U.S. Department  
of Transportation  
**Federal Highway  
Administration**

In Reply Refer To: HSSD/B-151

Name of device: Permatile Precast Concrete Barrier 10 foot length  
Type of device: Portable concrete barrier  
Test Level: NCHRP Report 350 TL-3  
Prior Testing conducted by: Texas Transportation Institute (TTI)  
Date of request: March 14, 2008

<b>TITLE:</b> PRECAST TRAFFIC BARRIER SERVICE CONCRETE - 10' V.D.O.T. STD. MB-7D PC (METRIC F-STYLE)	DATE: 9-11-98	DRAWN BY: RDW	DWG NO: VDOTTBF.DWG
	PRODUCT: TRAFFIC BARRIER	CHECKED BY: CJR	SCALE: AS NOTED
	CONTRACTOR:	CUSTOMER NO.	SHEET 1 OF 1
	PERMATILE ORDER NO.

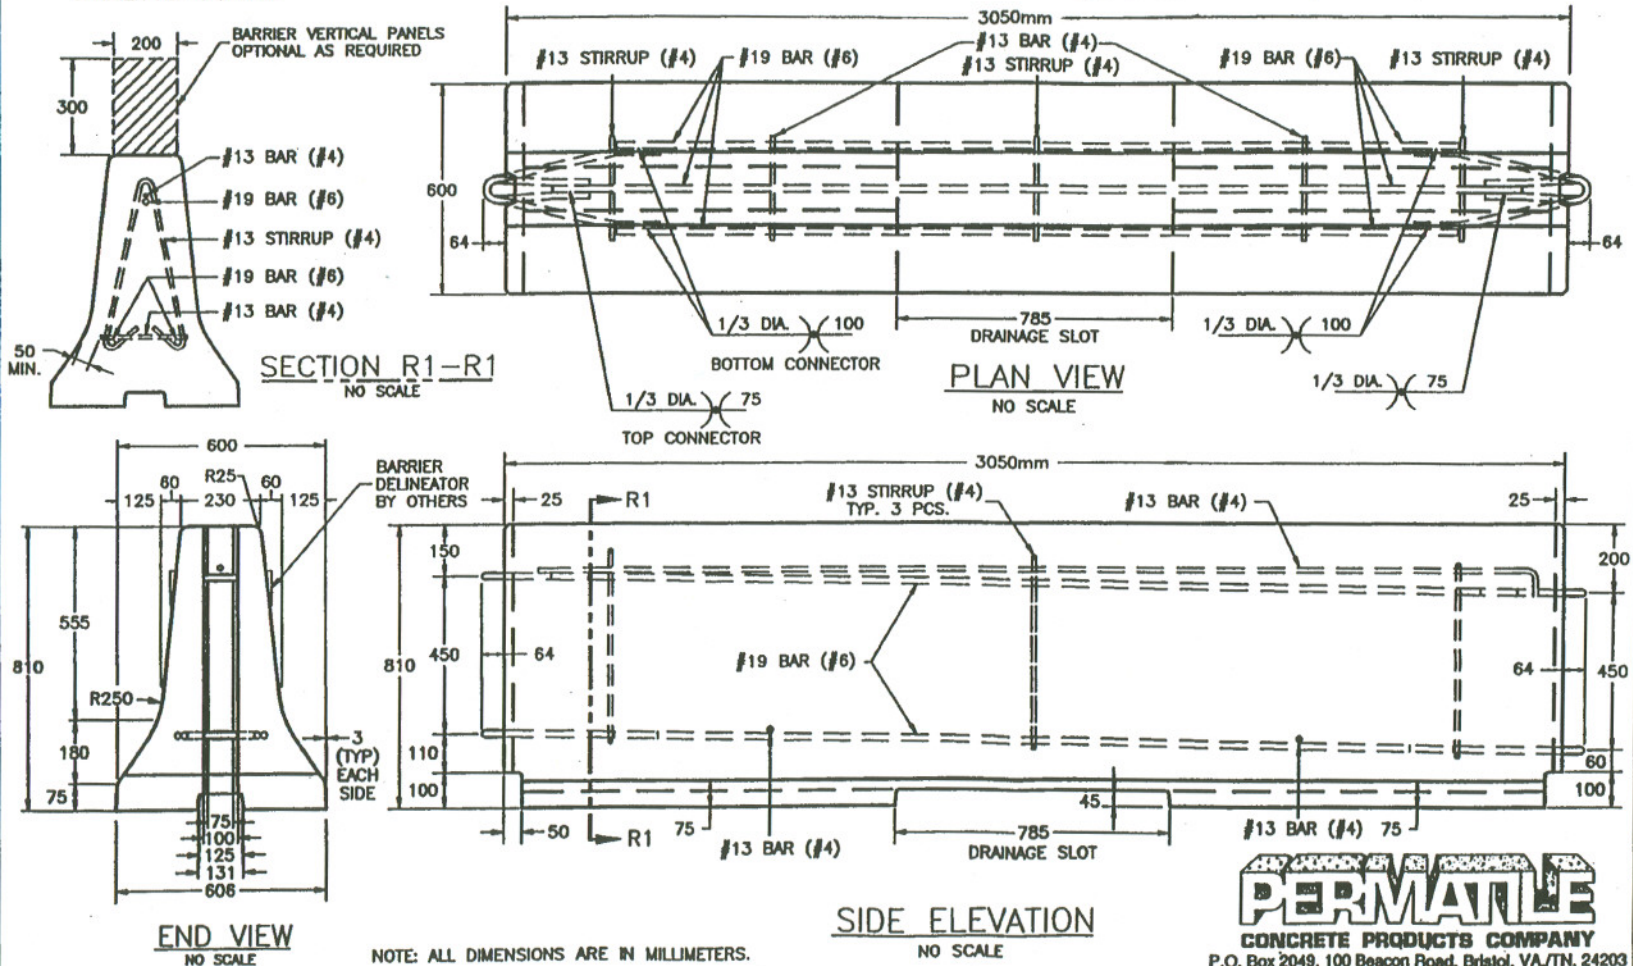
You requested formal acceptance of the Virginia Department of Transportation (VDOT) 10 foot F-shape Concrete Barrier with the pin and loop positive connection. A 20 foot version of this design (Scan01.tif, enclosed for reference) was tested and accepted for use as a TL-3 NCHRP 350 temporary barrier in FHWA Acceptance Letter B-54 dated May 18, 1999. Permatile Concrete Products Company manufactured and supplied this barrier that was tested by TTI under NCHRP report 350 Test 3-11, Contract No. T99011 and Project No. 402041. The drawings "Scan02.tif" and "Scan03.tif" include the details of the 10' version and are enclosed for reference.

The 20-foot long version of the VDOT barrier was successfully crash tested as noted above. Through the observation of crash testing of numerous portable concrete barrier segments of varying lengths over the years FHWA has learned that the length of the barrier plays little, if any, role in the successful performance. As long as the steel reinforcing and the integrity of the end connections are maintained, the shorter barrier length will be acceptable for use.

The 10-foot long VDOT barrier described above and detailed in the enclosed drawings is acceptable for use on the NHS under the range of conditions that the 20-foot barrier was tested, when proposed by a State.
